**CHANGE ORDER REQUEST SUMMARY**

PROJECT : Spring Lake Park City Hall Renovation / Expansion

# Proposal Request

PROPOSAL REQUEST NO: 10  
DATE: 7/15/2024  
PROJECT NO: 193806049  
CONTRACT FOR: Building Construction

SURVEY	DRAWN	DESIGNED	CHECKED	APPROVED	PROJ. NO.	SHEET NUMBER
	KEL	KEL	MTF	MTF	193806049	E304

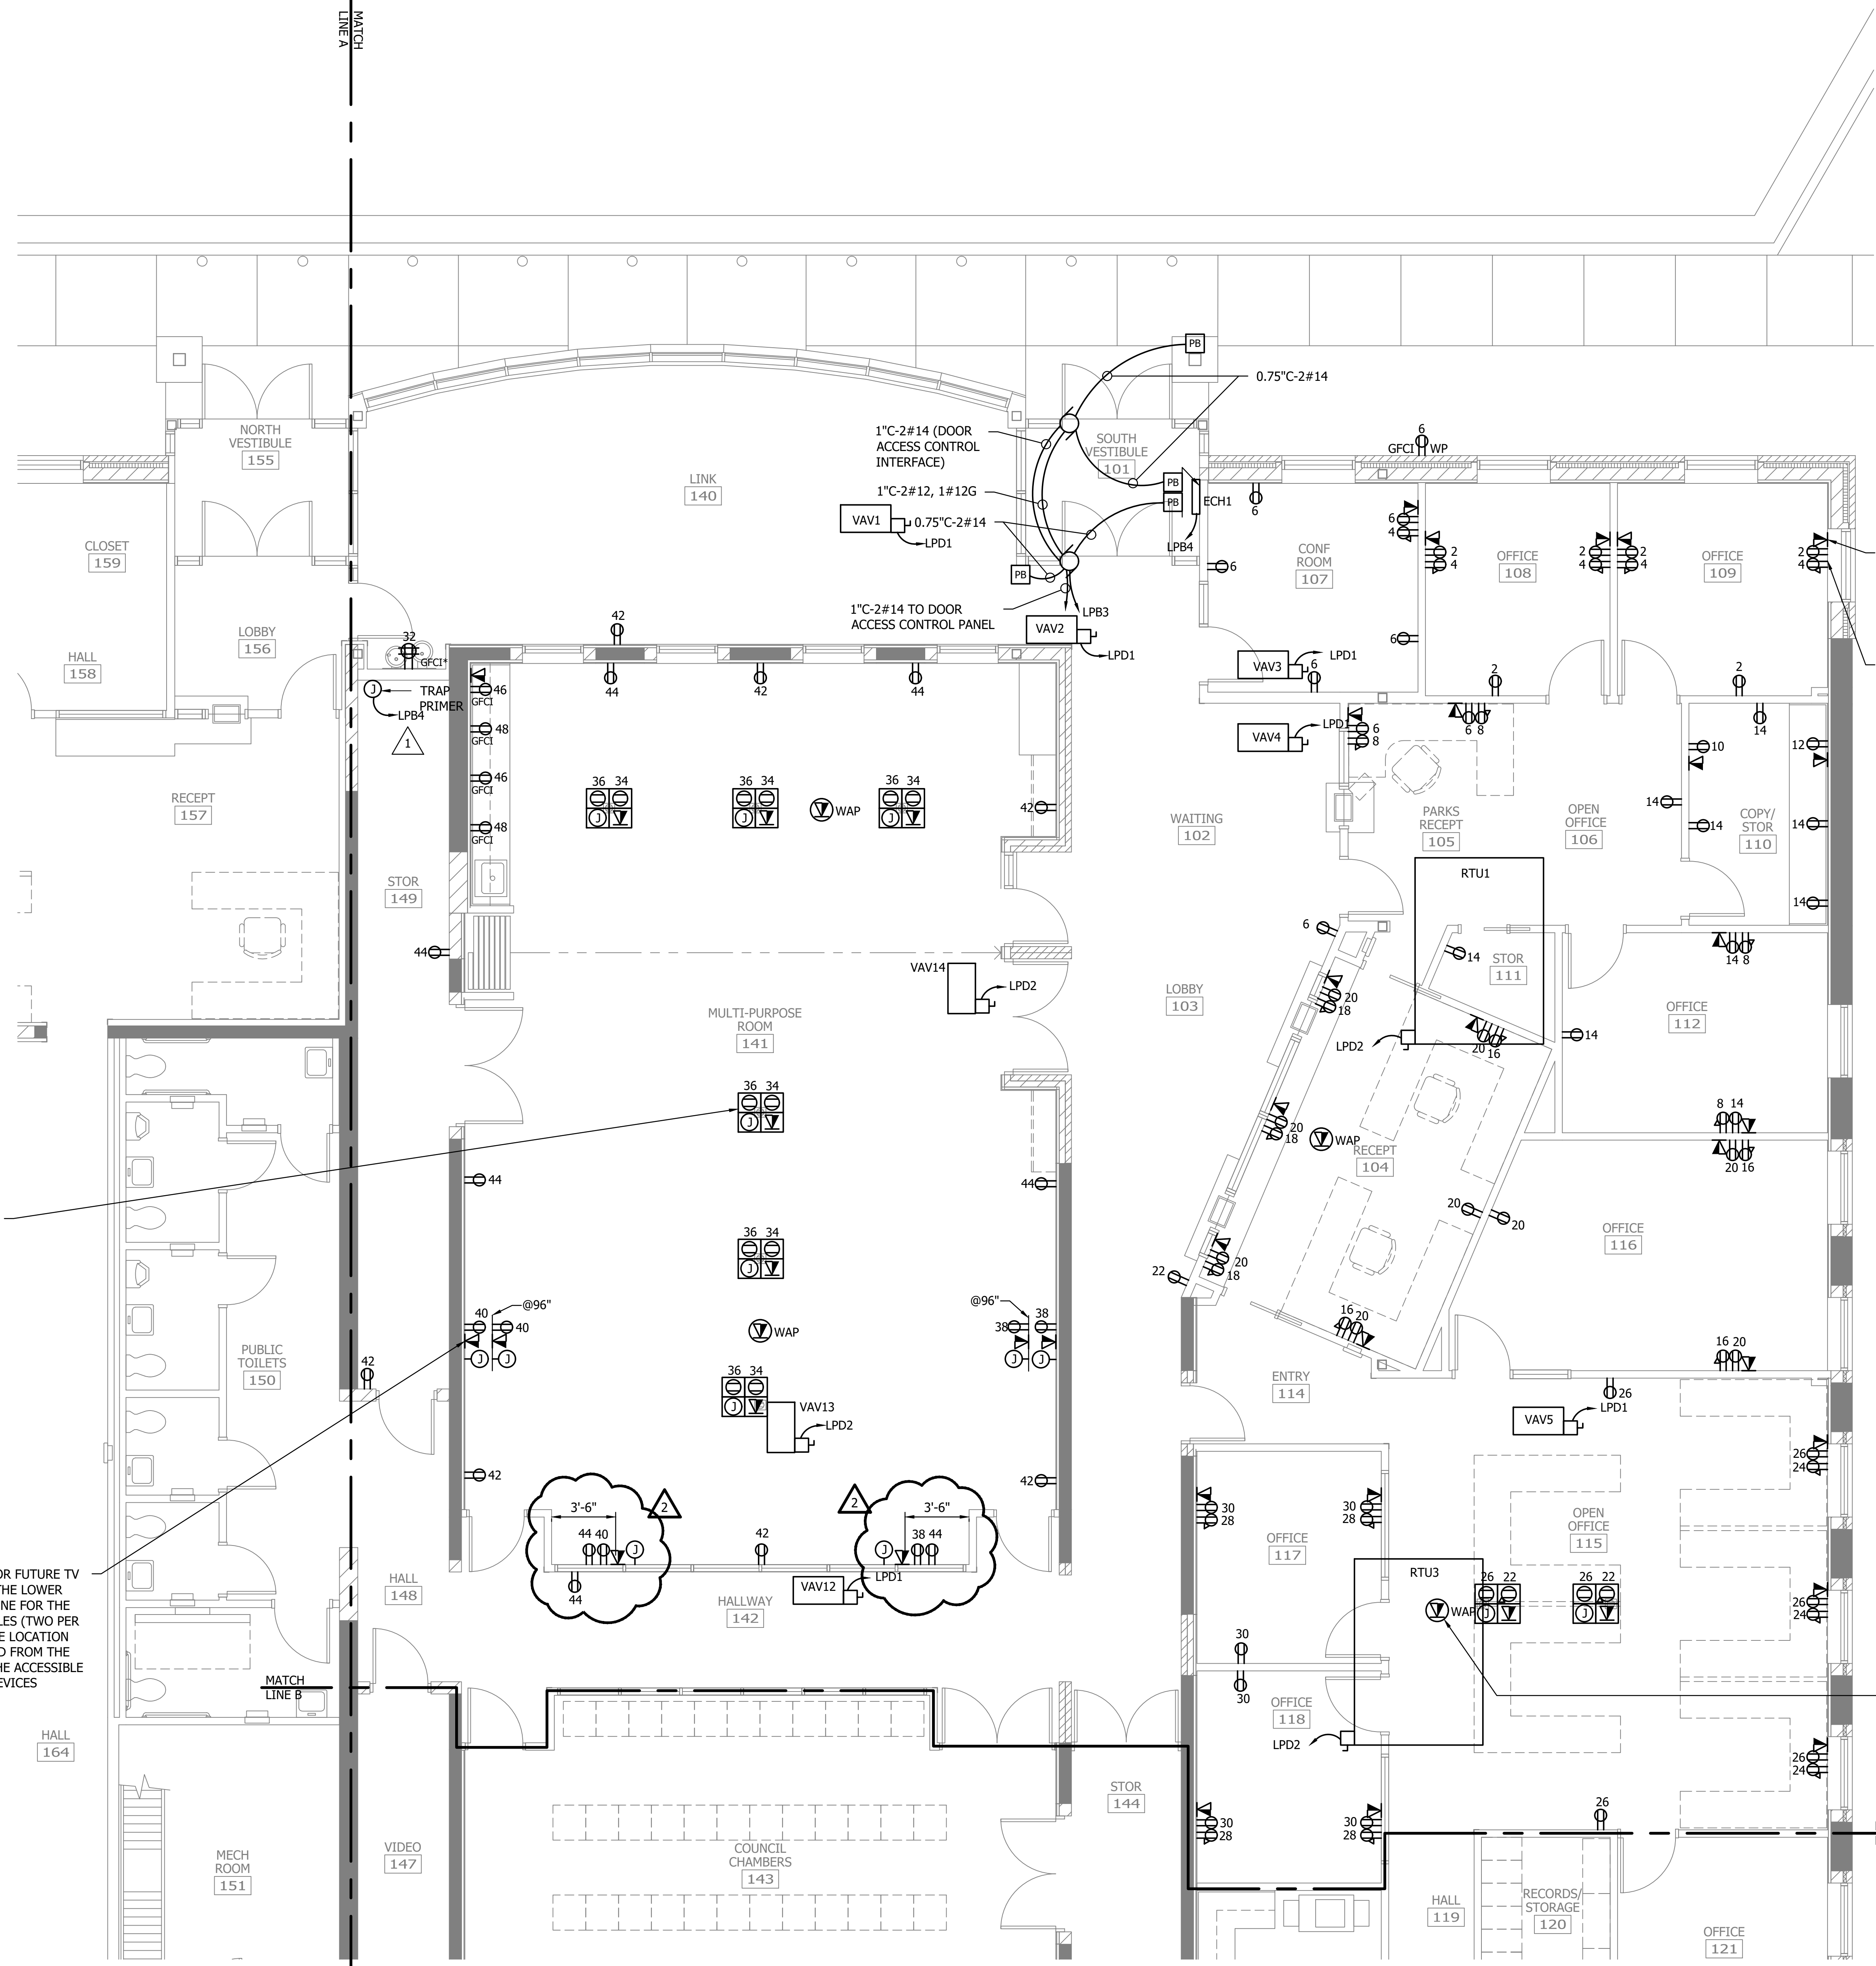
1. Revise floor plan to add three (3) double duplex receptacles in Police Storage 170 as indicated.

1. Revise floor plan to add a receptacle, E-Stop, and a safety disconnect for the adult changing station as indicated.

PROJ. NO. 193806049  
 SHEET NUMBER  
**E303**

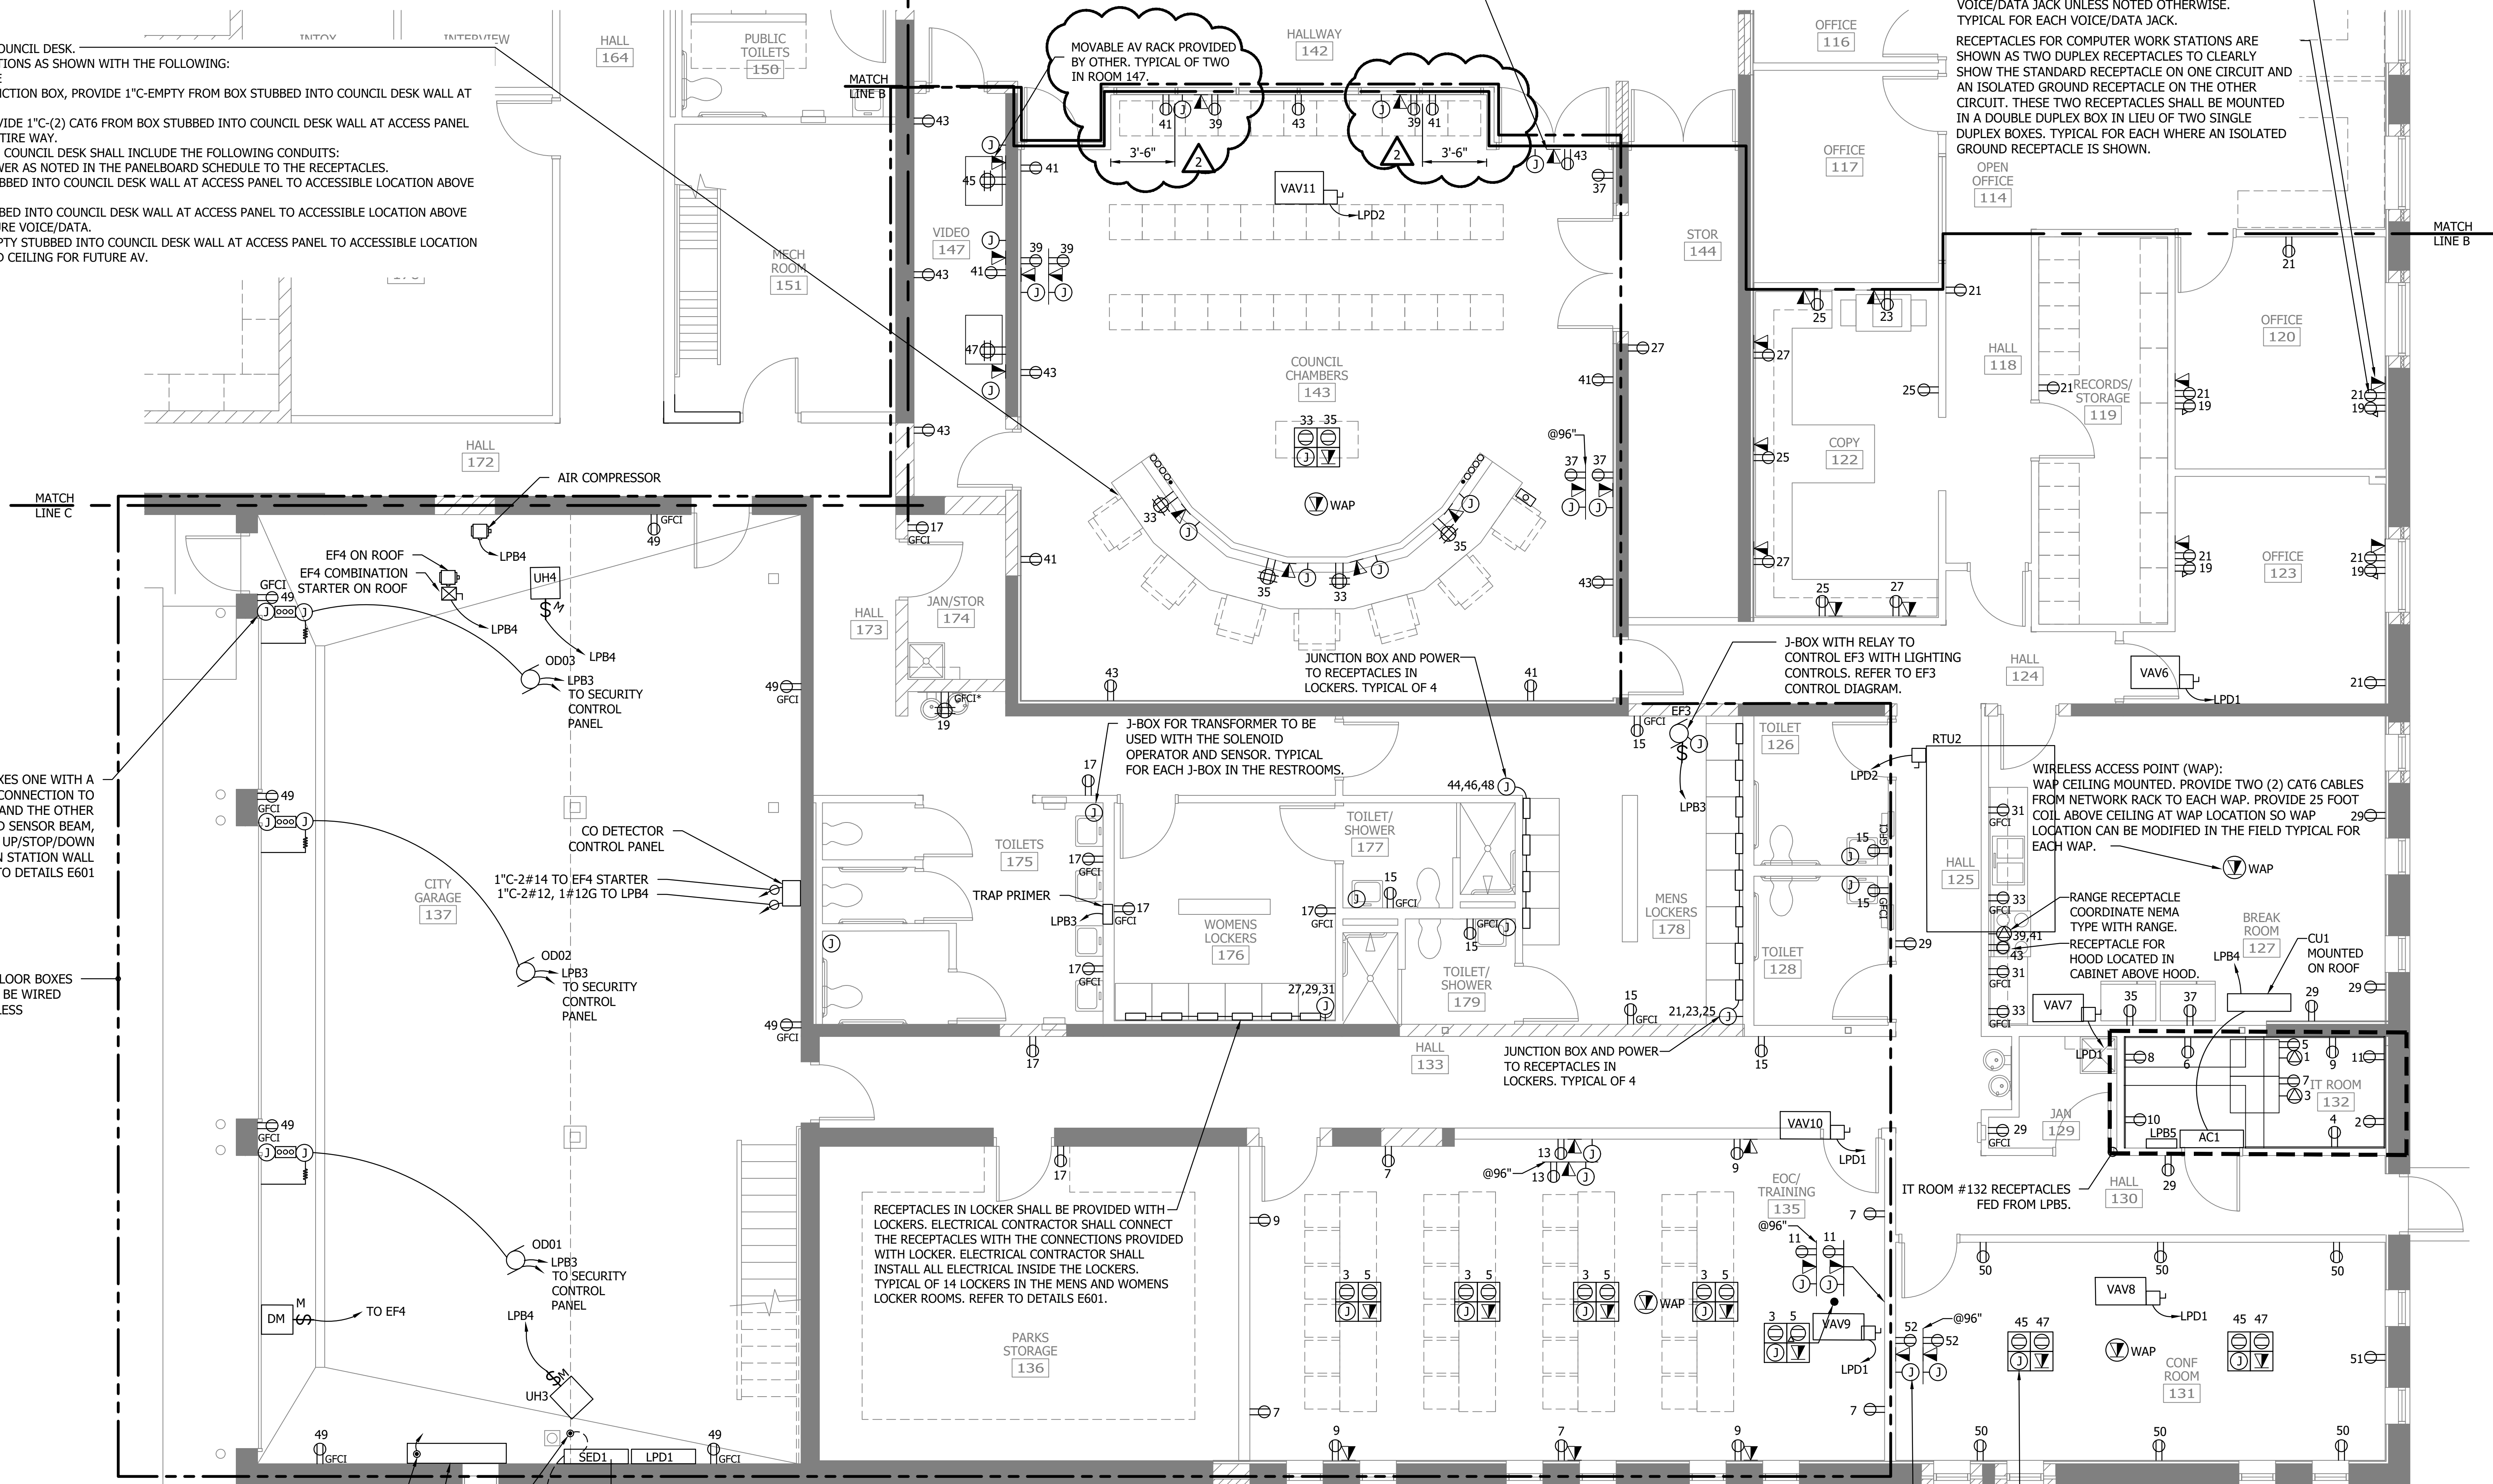
1. Revise power plan to add receptacles mounted close to the precast concrete roof planks as indicated.

**MAIN LEVEL PARTIAL ENLARGED POWER PLAN**  
0 2' 4' 8'

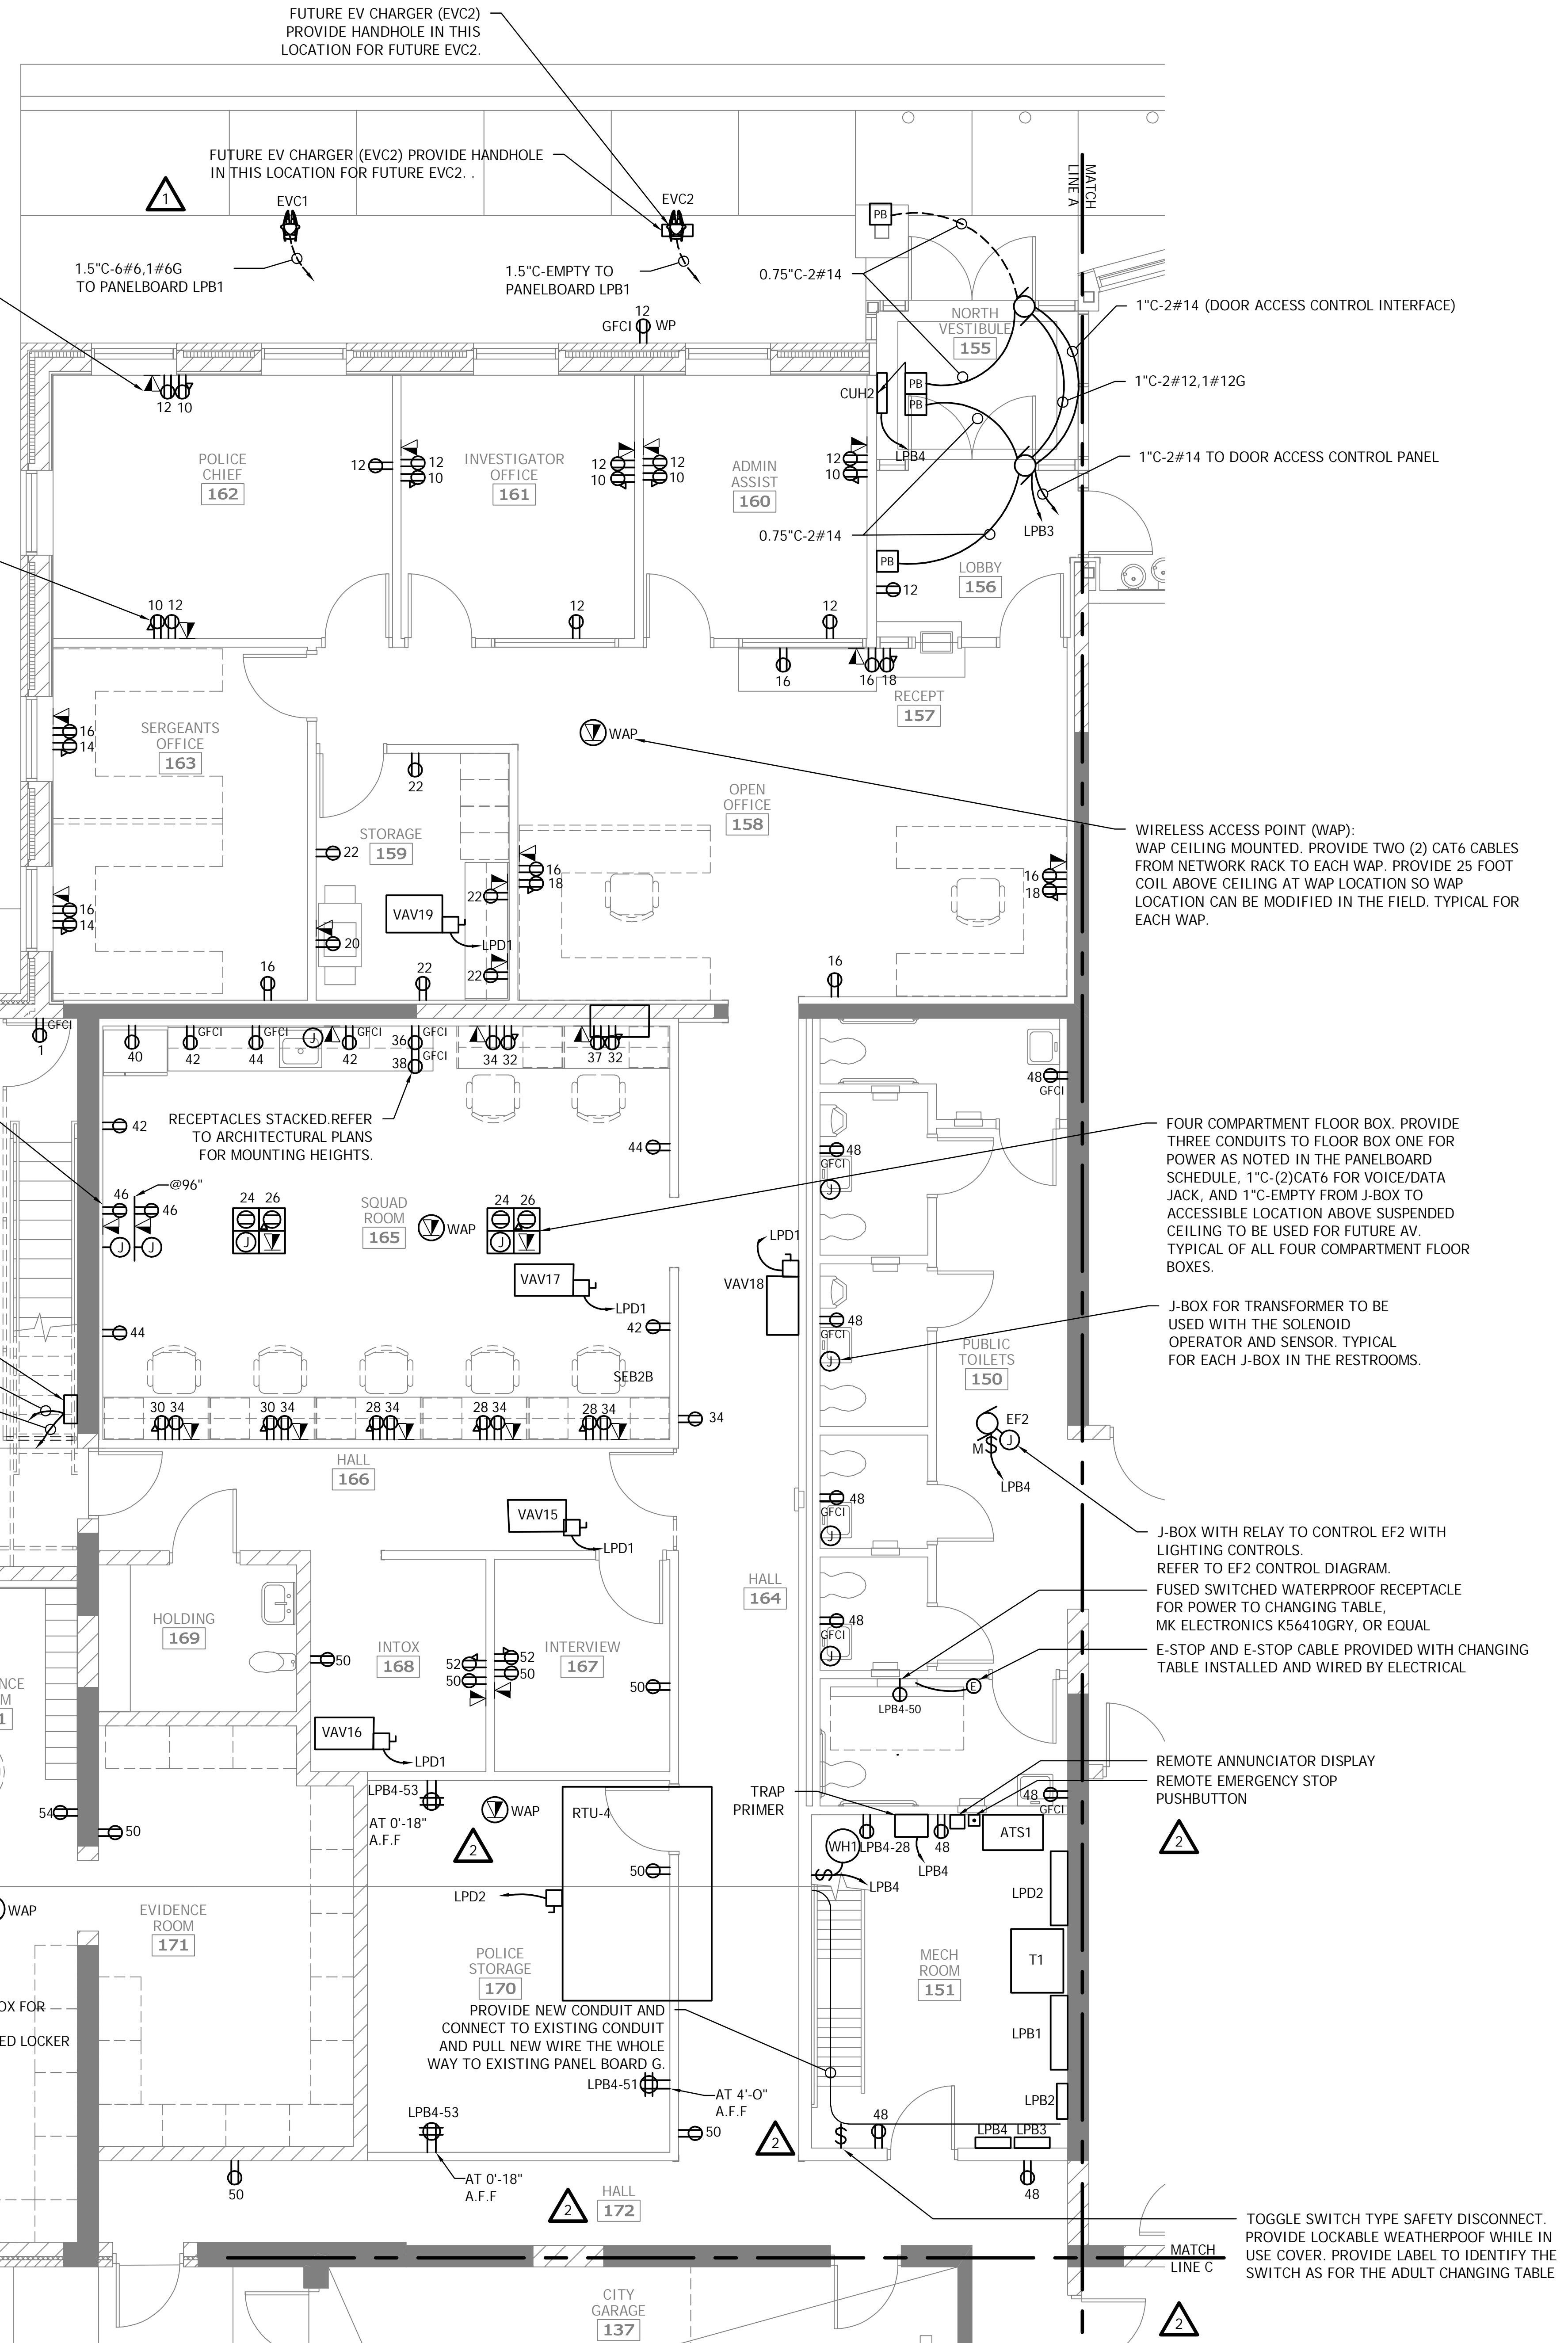
1. Revise plan to add power and data receptacles mounted on the south wall of Police Garage 183 just west of the pass-thru evidence lockers as indicated.
